LA VISTA CITY COUNCIL MEETING AGENDA

December 19, 2017

Subject:	Type:	Submitted By:
APPLICATION TO AMEND PUD SITE PLAN – LOTS 14-A AND 15-A, SOUTHPORT EAST REPLAT EIGHT AND LOTS 1-4, SOUTHPORT EAST REPLAT NINE (SOUTHPORT PKWY & EASTPORT PKWY)	◆ RESOLUTION ◆ ORDINANCE RECEIVE/FILE	CHRISTOPHER SOLBERG CITY PLANNER

RE: Proposed Securities American Expansion & Offsite Parking Lot Facility
Amendments to PUD Plans-Ordinances 1020 and 1045

Exhibit D1

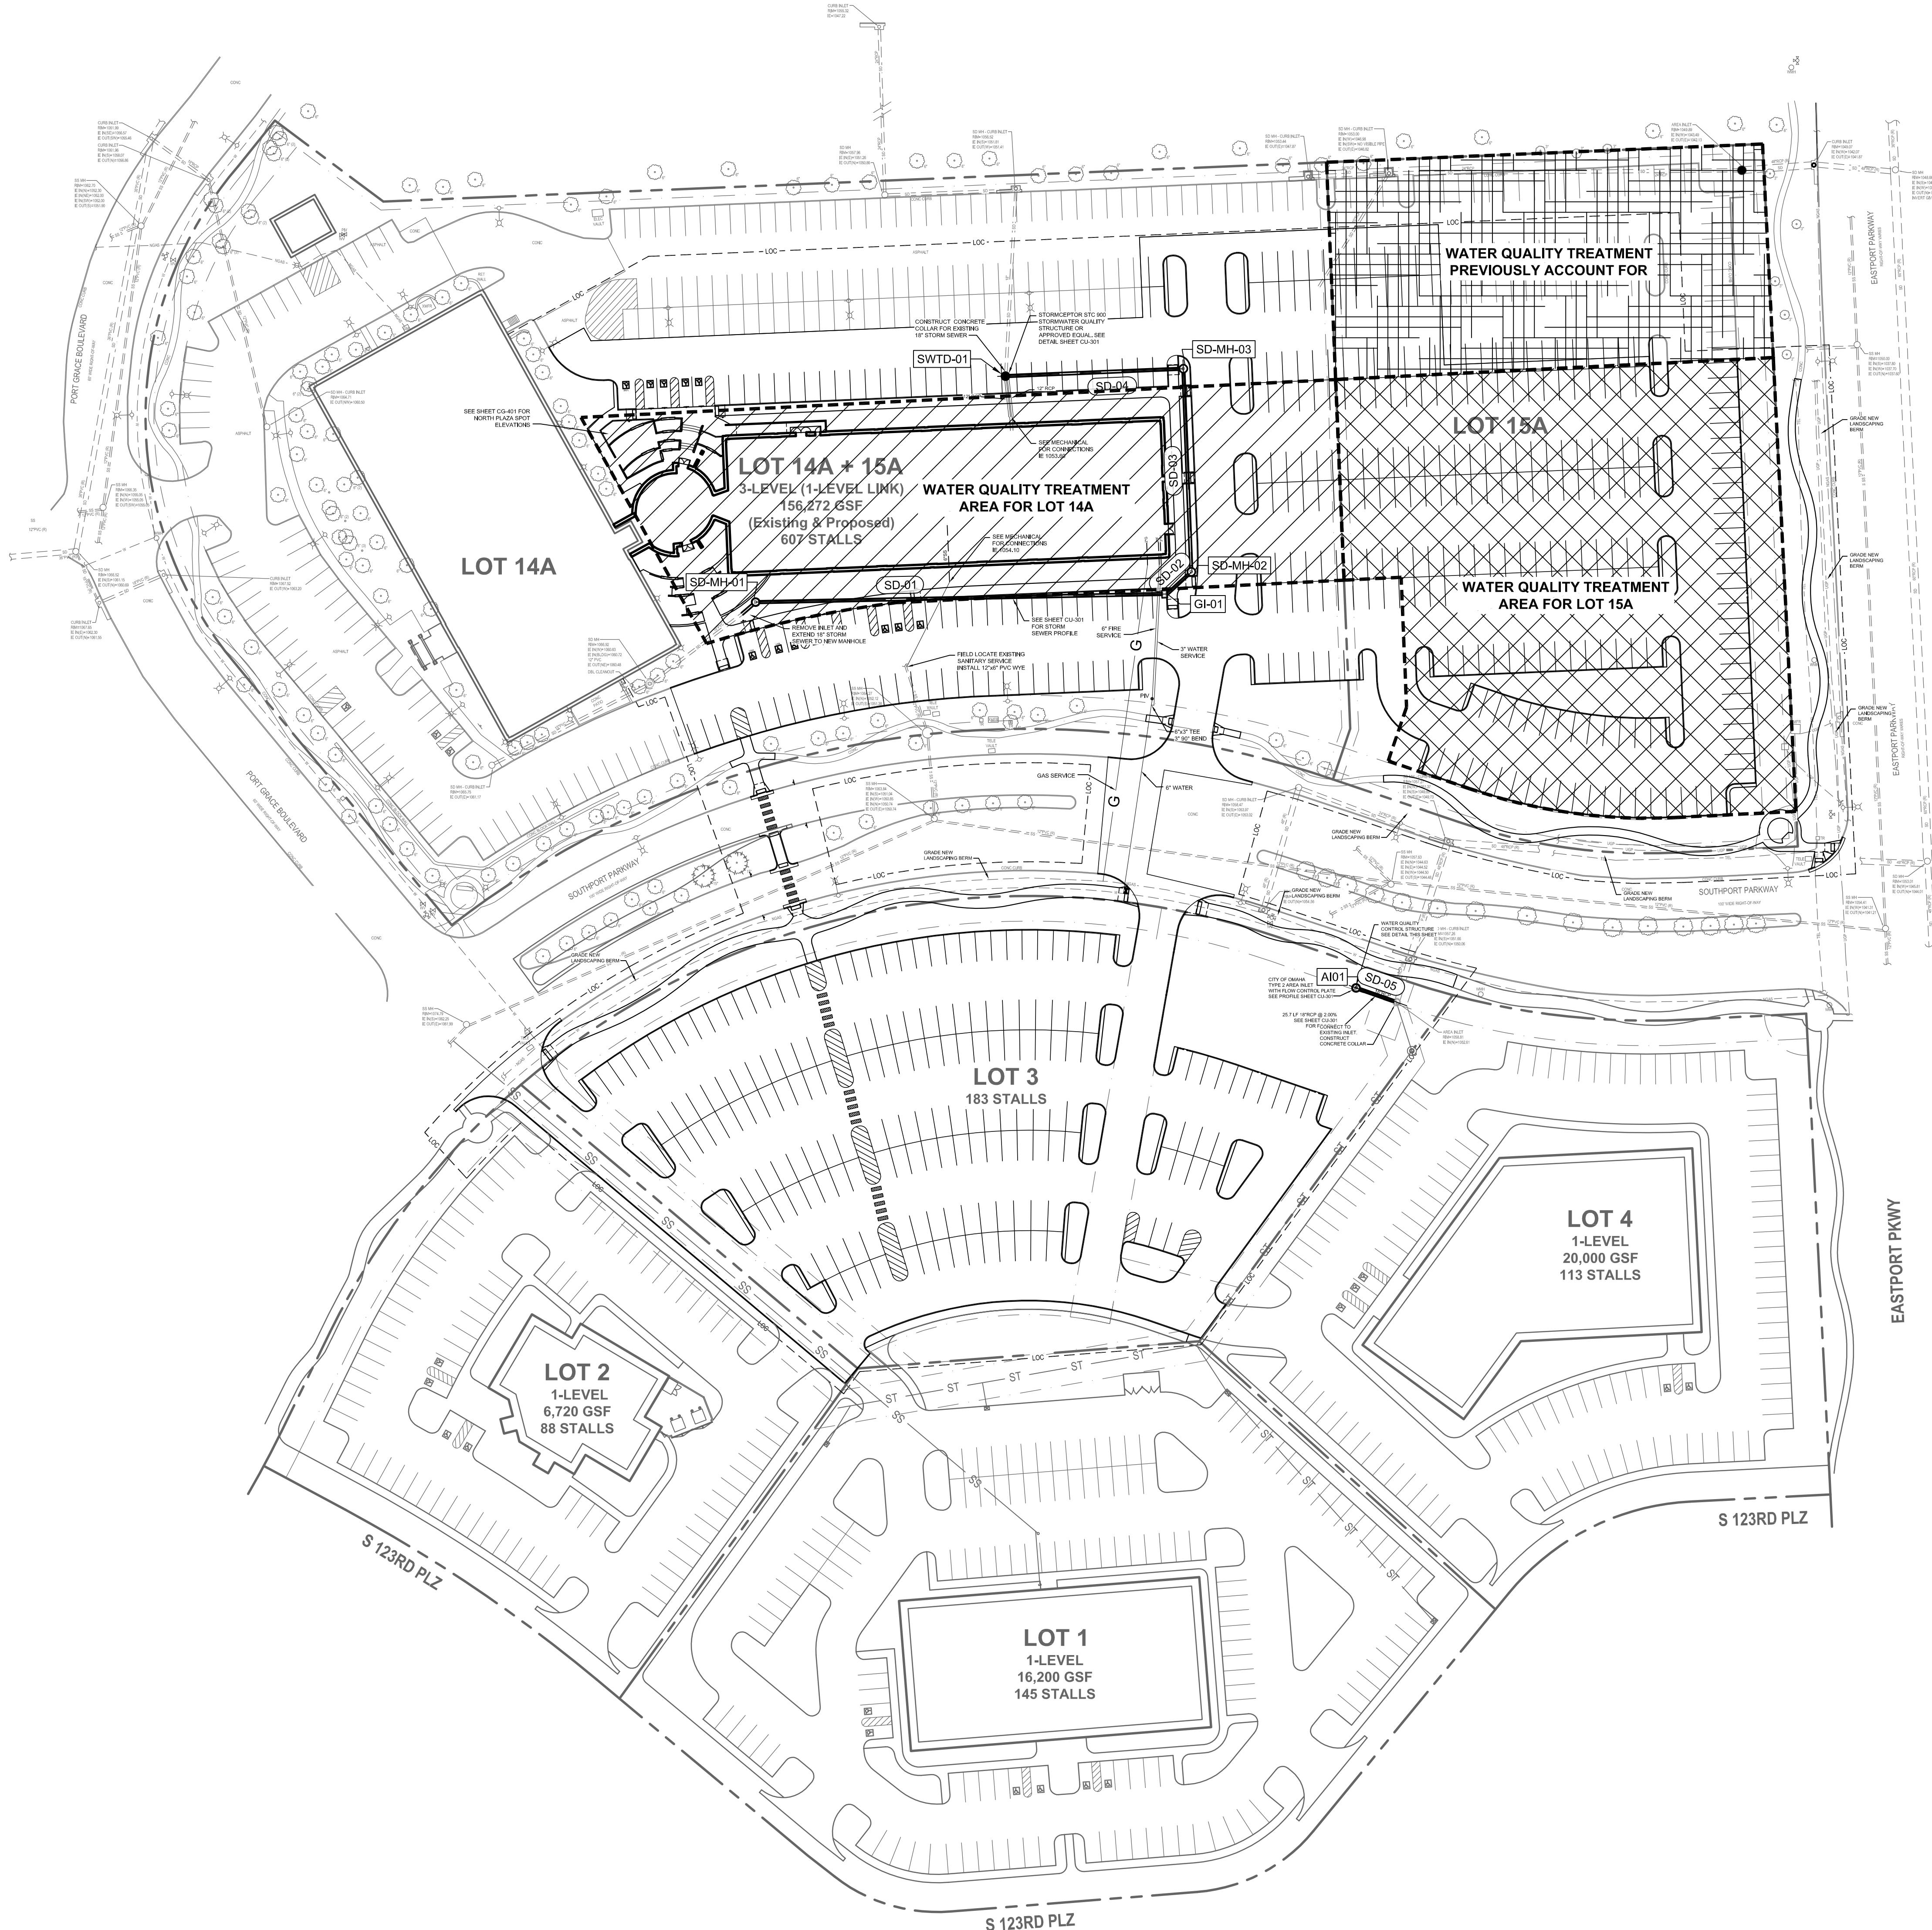
18. Article 5.15.05.04: See Item 6a above. Also, revise Exhibit D1 to show the portion of Lot 14A and 15A that will need to receive water quality treatment for compliance with Chapter 154 of the La Vista Municipal Code for new impervious surface and significant redevelopment. With this letter is an exhibit of what portion the City Engineer interprets as coming under this requirement.

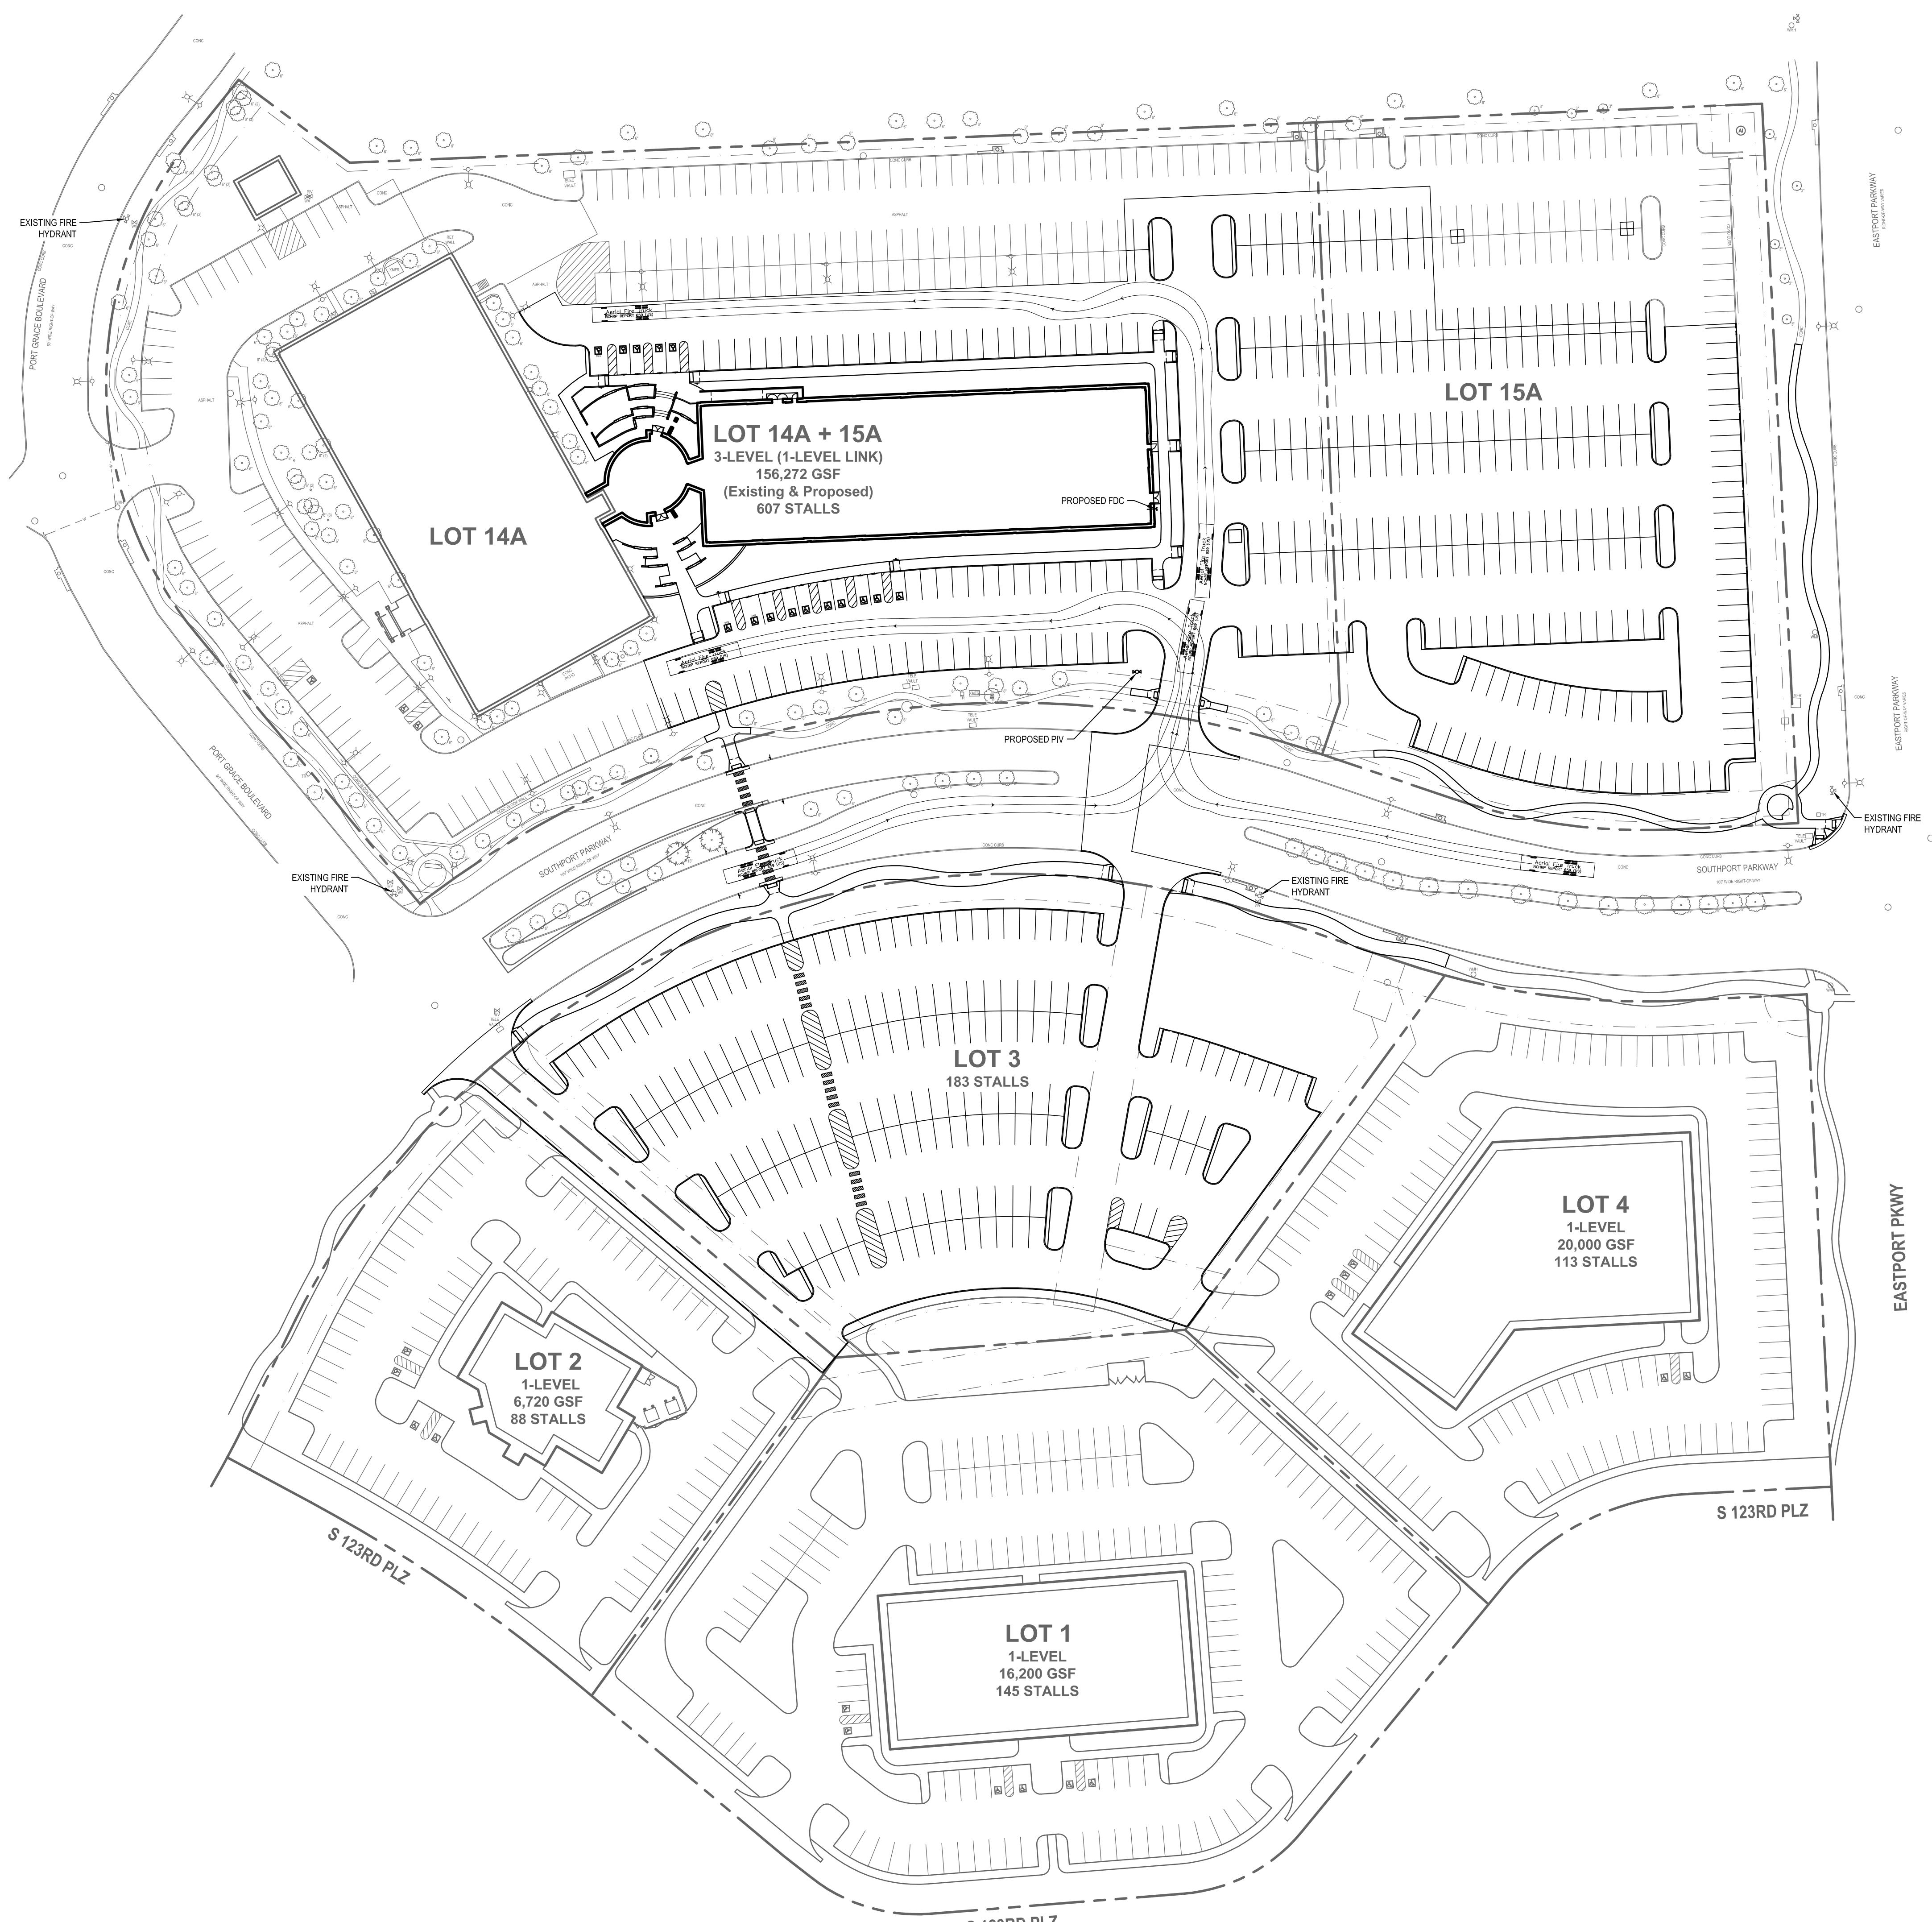
1. The Papillion Fire Marshall's office has reviewed the revised Emergency Vehicle Turning Plan and has approved of the plan to be contingent upon applicant's resubmittal and further demonstration that the requirements of 1, 2 and 3 as listed above, are met for proposed future development of Lots 1, 2 and 4 at the time of development.

See revised Emergency Vehicle Access Plan - Exhibit E.
